Service information

Reference no.: SDA_83598

ON-OFF defect, Unit doesn't turn on

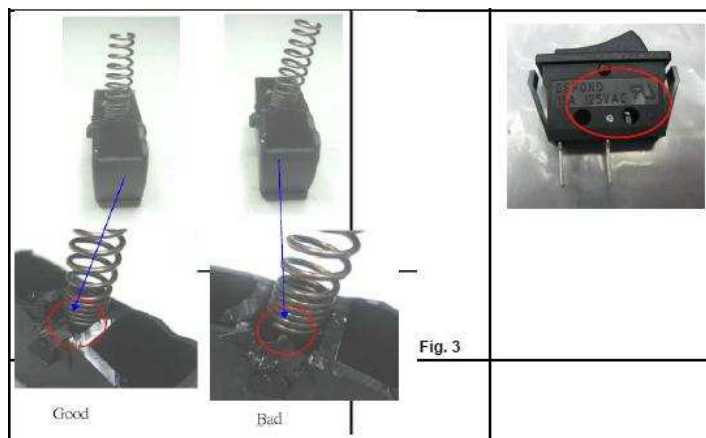
Symptoms: Unit doesn't turn on, Unit goes off when switching steam selection

Cause: Intermittent connection on power-switch resulting in no close connection on switches. Product after affected production week 100% re-worked.

Cure: Replace Display Panel printed assy (Position 47). In this manner, affected switch module replaced.
